Aircraft Design Certification GmbH Reichensteinstr.48 69151 Neckargemünd		Bristell B23	Doc-Nr: ADxC-73-SB-029 Issue: A Date: 09.02.2023 ChangeNr.: ADxC-73-DC-092
Service Bulletin

<p style="text-align: center;">Bristell B23</p> <p style="text-align: center;">Inspection and change of ballast attached to engine</p>

ATA 72 ENGINE – ballast attached at engine

Figure 1 Installation drawing (showing Ballast 71B200201 Issue E. The reworked Issue D has straps instead of patches

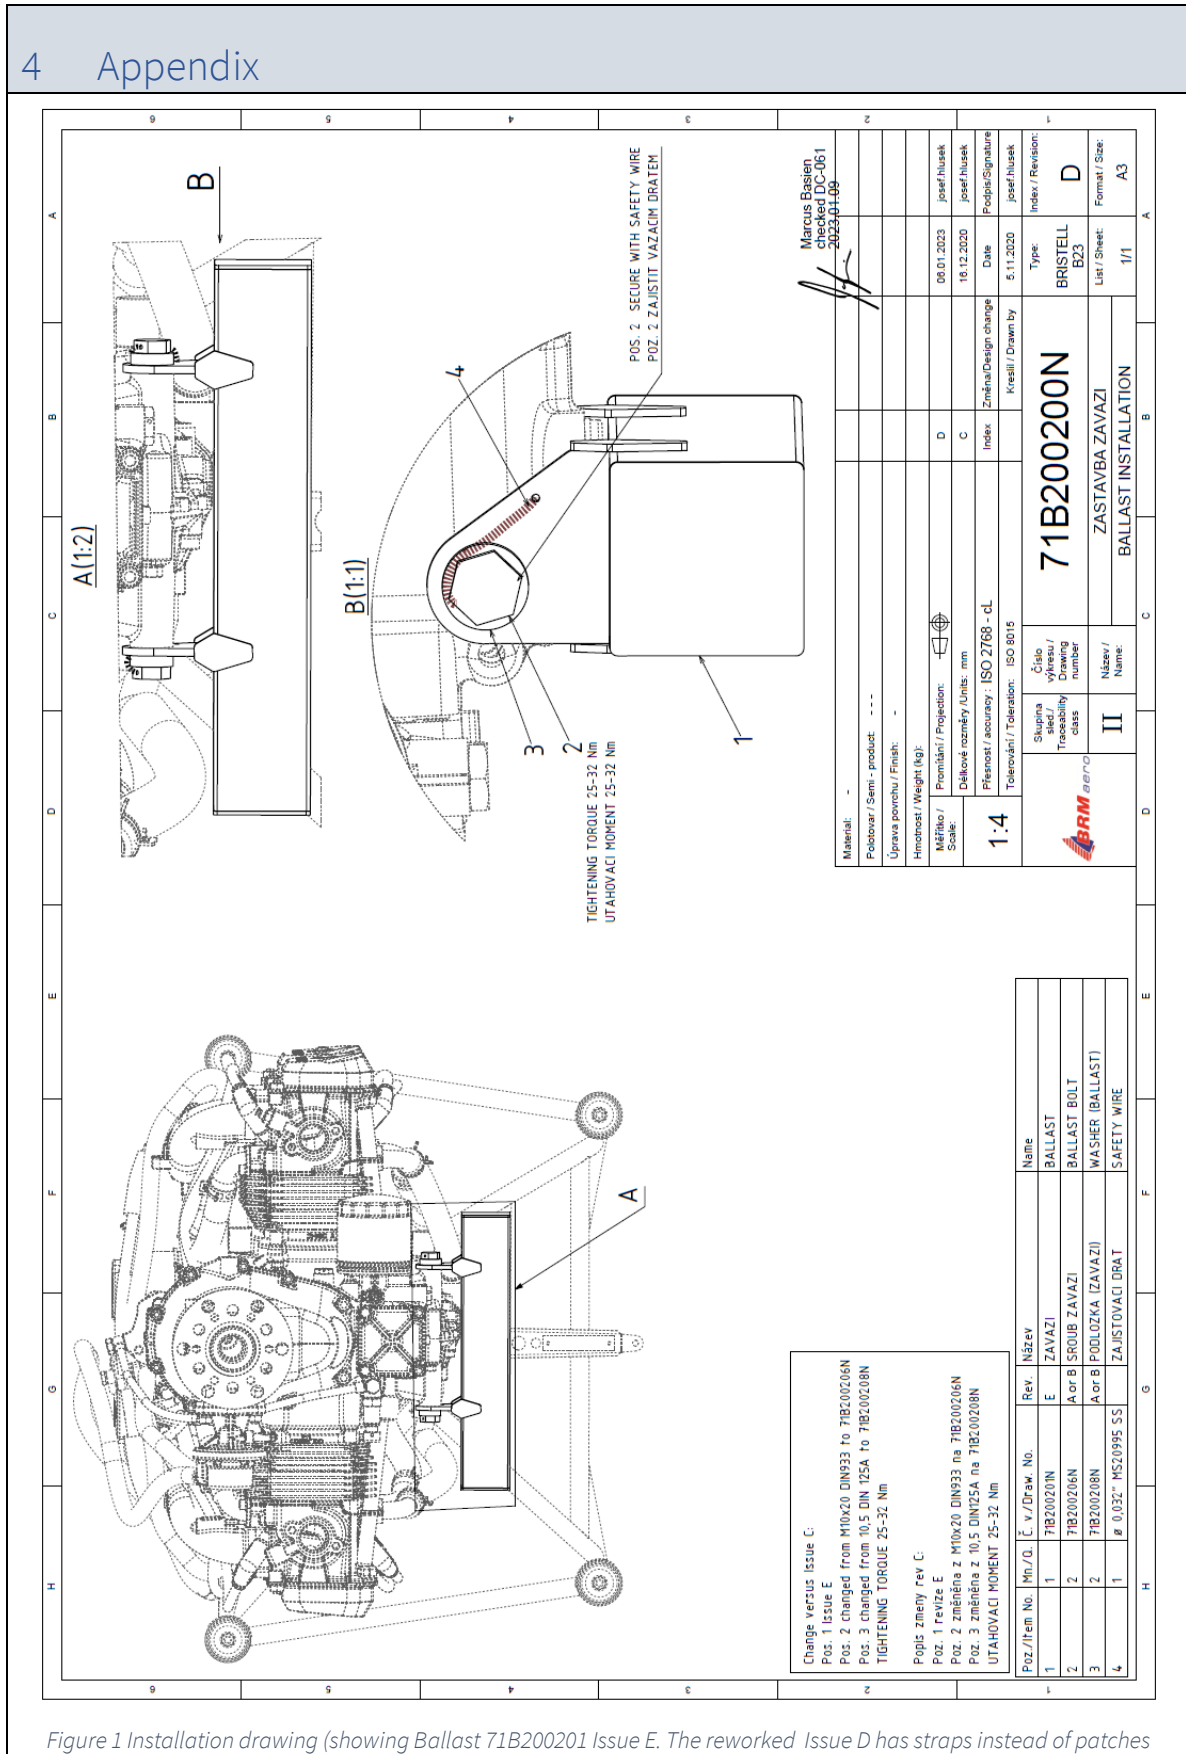
- Remove engine cowling
- Remove safety wire at ballast attachment bolts
- Install factory reworked ballast PN 71B200201N issue D (*OR new 71B200201N issue E Ballast*) using bolts PN 71B200206N issue B and 71B200208N issue B washer (2ea) according installation drawing 71B200200N issue D; Torque attachment bolts to 26-32 Nm
- Perform engine run up according AFM, perform minimum 5 rapid RPM changes idle to max RPM. Shut down aircraft according AFM.
- Recheck torque of bolts PN 71B200206N issue B after cool down.
- Reapply safety wire.
- Reinstall cowling.

Figure 2 Cracks found on ballast lug

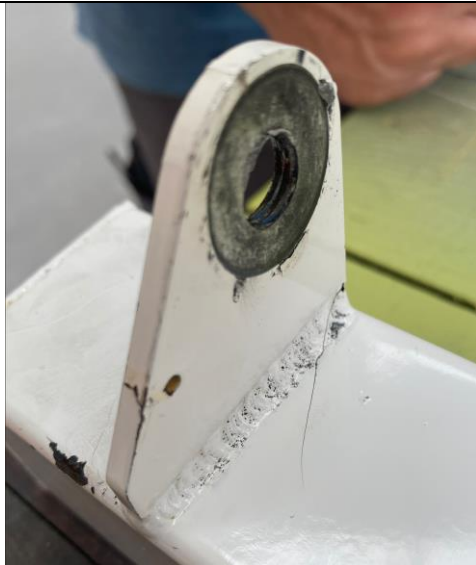
- Visually inspect ballast for cracks: no cracks allowed, see Figure 2
- Visual inspect ballast attachment lug holes – no elongation or wear allowed. Nominal diameter of hole 10.0mm tolerance +0.015/-0.0

- Remove engine cowling
- Visually inspect ballast for cracks: no cracks allowed, see Figure 2
- IF cracks are found sent to BRM for repair/upgrade (immediate terminating action).
- IF ballast is free of cracks: Reinstall cowling.

- If cracks or hole wear is found sent to BRM for repair/upgrade (immediate terminating action).
- If ballast is free of cracks or hole wear reinstall ballast (mind correct orientation) using 71B200206N issue B Ballast bolt (2ea) and 71B200208N issue B washer (2ea)

Figure 4 Grey dust on ballast indicating wear on bolt/thread/attachment)

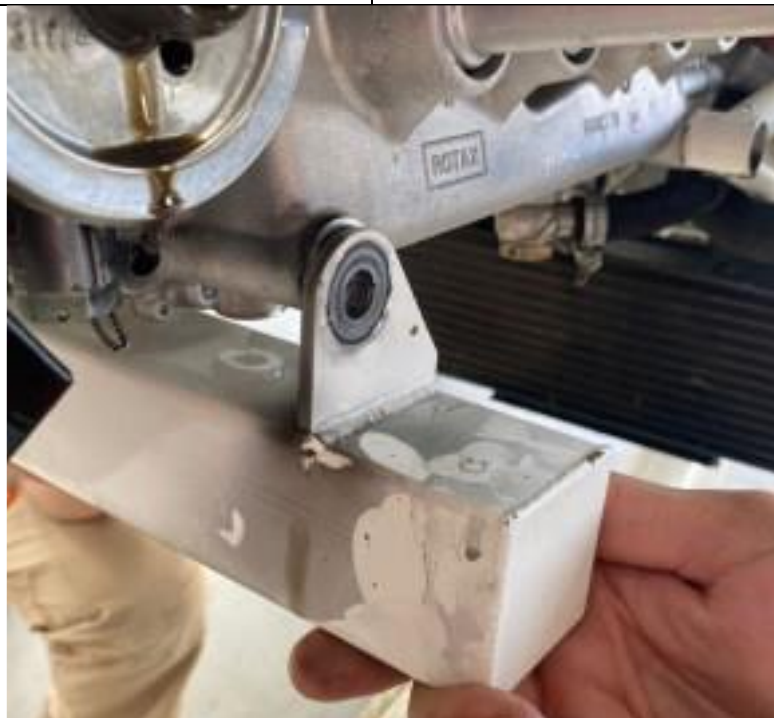
- Remove engine cowling
- Visually inspect the surface of the ballast for cracks occurrence in the area of attachment to the engine and/or signs of a loose connection indicated by the appearance of grey-black dust, see Figure 4 in Appendix.

- Remove safety wire at ballast attachment bolts
- Remove bolts and ballast
- Discard bolts
- If grey dust was found: Visual inspect engine threaded hole: no thread damage is allowed. In case of thread damage contact BRM, installation of helicoil might be needed.
